Durango River View RV Resort, LLC

RE: Project # PL2023-0036, Durango Village Camp Third Compliance Review

**DURANGO VILLAGE CAMP SKETCH PLAN**

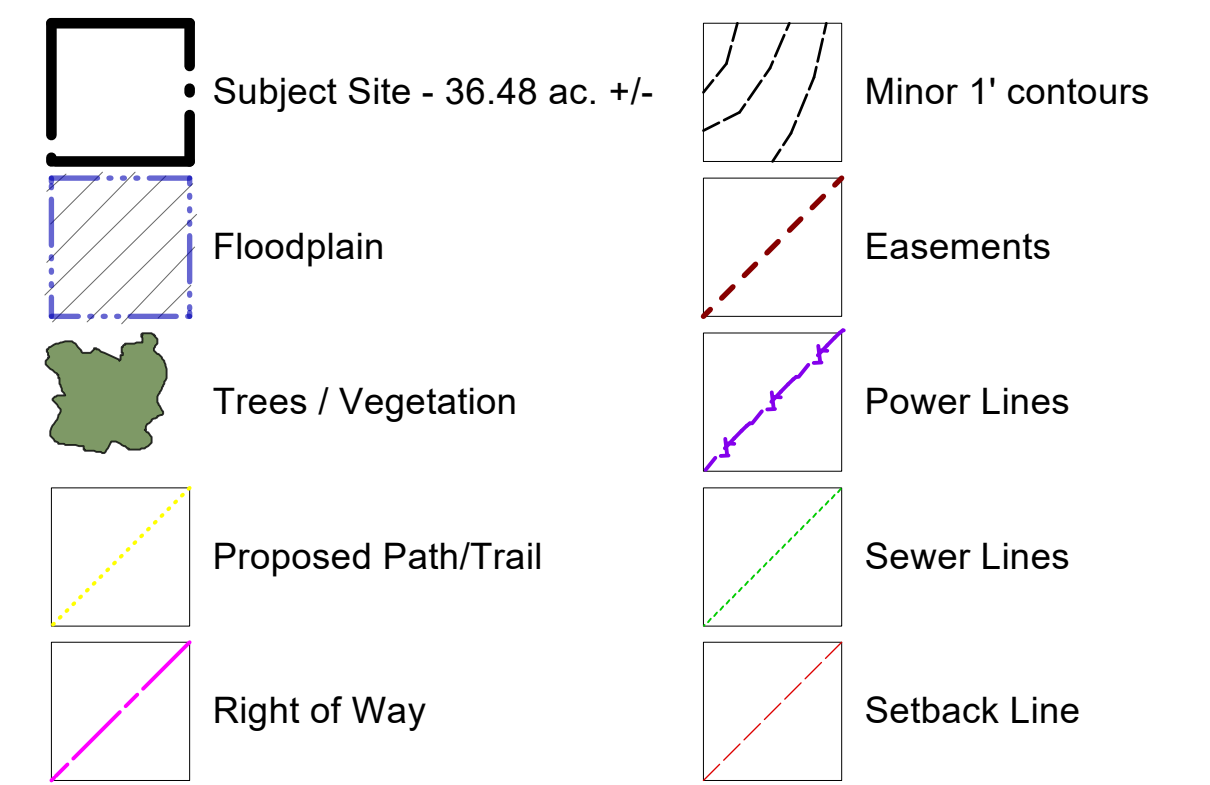
7. **[Unaddressed Comment].** Durable, water-tight, easily cleanable refuse containers, sufficient to contain all the refuse, shall be provided at each service building and sanitary waste station or at a central storage area readily accessible and located not more than 300 feet from any camp or picnic site unless provided at the campsite. Refuse containers shall be provided at the rate of eight cubic feet (60 gallons) for every five campsites or the equivalent thereof if containers are provided at individual sites. ([6 CCR 1010-9, State Campground Regulations](#)). **The single dumpster shown on the plan meets the cumulative volume requirements; however, it's not located within 300 feet of each campsite. The applicant also responded to this comment, stating that an adequately sized trash disposal was located near the clubhouse kitchen; however, no trash disposal is shown near the clubhouse kitchen. Per the state campground regulations, there needs to be a receptacle at every service building, including the clubhouse and bathhouse, that cumulatively meet the total volume requirements, or a receptacle within 300 feet of each campsite that cumulatively meet the total volume requirements.**
